## Mark Brown - Submission re Sharks Project from North Cronulla Precinct Committee

Dear Michael,  
 Re: Concept Plans for Cronulla Sharks Development Woollooware(MP10\_0229 and MP10\_0230)

**SUBMISSION FROM NORTH CRONULLA PRECINCT COMMITTEE 7 May 2012**  
**RE: CRONULLA SHARKS DEVELOPMENT PROPONENTS RESPONSE**

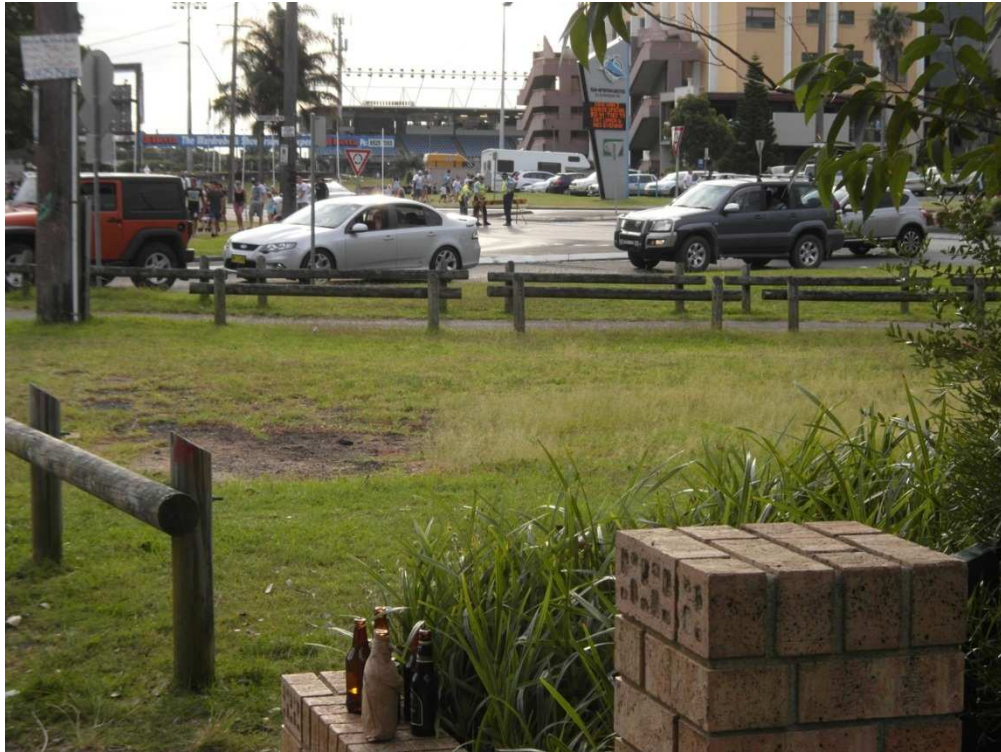
*Game day parking –no parking allowance at the site*

- Currently there is no parking available on Captain Cook Drive between Gannons Road and Woollooware Road.
- Work is commencing from May 2012 on the widening of Captain Cook Drive between Woollooware Road and Elouera Road. Cars currently park on both sides of this sector of Captain Cook Drive on game days/nights. There will be a loss of at least 200 car spaces once the widening of this road is available 500 overflow parking spaces on left of club are now lost to the club by the residential high rise development.

- Council has refused game day parking at Wanda car park, Cronulla and Woollooware High schools and Seymour Shaws.
- There will be no parking space available in retail complex due to pressure of retail clients, club patrons who may come early to use the club and see the game, and staff parking.

- If all game day patrons came by bus, an estimated 200 buses would be required!
- Again proponent relies on “strengthened public transport connections to reduce the need for local parking. Also points to a “subregional transport approach for major events with connections to Engadine, Gymea Menai, Sutherland, Caringbah and Miranda”. This is not in place either. In fact the existing community support offered by Sharks to major events such as the Easter Show or major sporting activities in the region will be withdrawn when the 500 additional spaces on the left of the club disappear to the 600 unit residential highrise. How can Sharks expect other space to become available with the pressure of increasing Sydney population soaks up any excess land spaces?

- The proponents only response is to add further shuttle bus services for game days, but there is no quantum on what additional buses may be required. If all game day patrons were to travel by bus, 200 buses would be required!
- Obviously there will be placed an unacceptable strain on the general community for parking spaces and Woollooware, Caringbah and Cronulla streets will be completely parked out.

*Caption: Captain Cook Drive blocked by Police as the game crowd leaves the Eastern Carpark. After Sunday afternoon match 15<sup>th</sup> April 2012, nobody could travel along Captain Cook Drive, with all traffic diverted up Woollooware Rd North, and Gannons Road. This is the chaos without a major shopping centre and 600 units, Kurnell traffic and an extra 450 homes up Captain Cook Drive at Greenhills Beach!*

Shark soup: Flooding on Captain Cook Drive outside Toyota Stadium. Picture: Troy Van Ryan

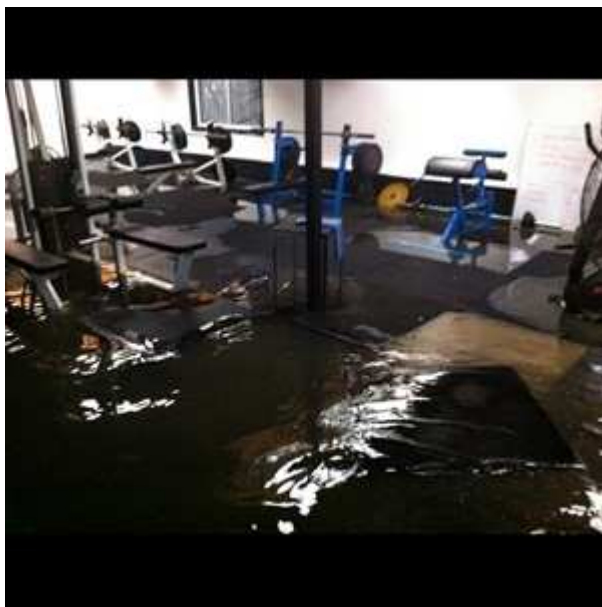
The proponent has not demonstrated that they are able to deal with the flood prone nature of the site, the photos below from the Local Leader show a recent storm event which flooded Captain Cook Drive , the playing fields and the Leagues Club. It is noted in Sutherland Shire Council Report 30/4/12 that the Club was required to implement a range of flood mitigation works (refer DA06/1007 & 1008). This work has never been satisfactorily completed and no approvals should be forthcoming until these approvals are fully complied with.

The proponent has not supplied any modeling for dealing with the flood events that are occurring on the land at present and these issues are only going to worsen in the coming years with Sea Level rises.

The above events happened at high tide during storms, the future impacts from sea level rises have not been addressed as per DGR Requirement. The proponent has not provided any modelling based on updated data and are relying on out of date data collected from previous Development Applications.
